CUSTOMER ADVISORY

ADV2002

Label Content Update for FPGA and Power Products

Table 2: Label Sample with “RoHS COMPLIANT”

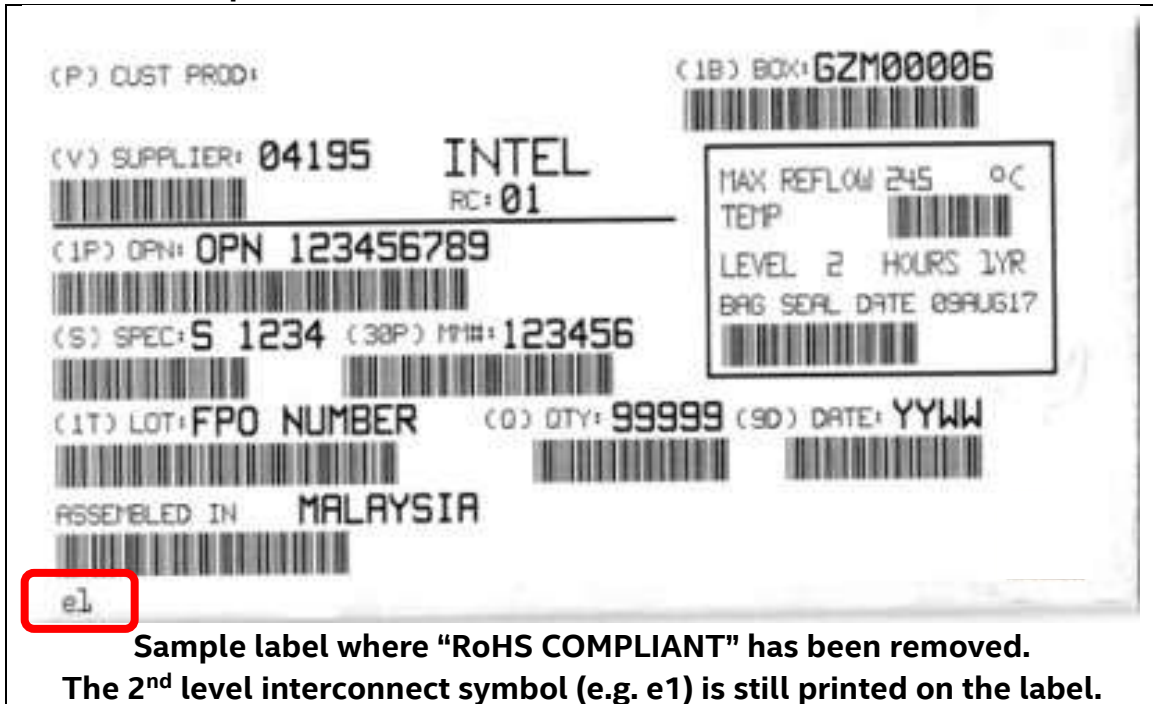
| Change From | Change To |
|---|---|
| "RoHS COMPLIANT" indicated on the lower left of the barcode label | Labels may or may not indicate " RoHS COMPLIANT " on the barcode label. The 2nd level interconnect symbol (e.g. e1) remains printed on the label. |
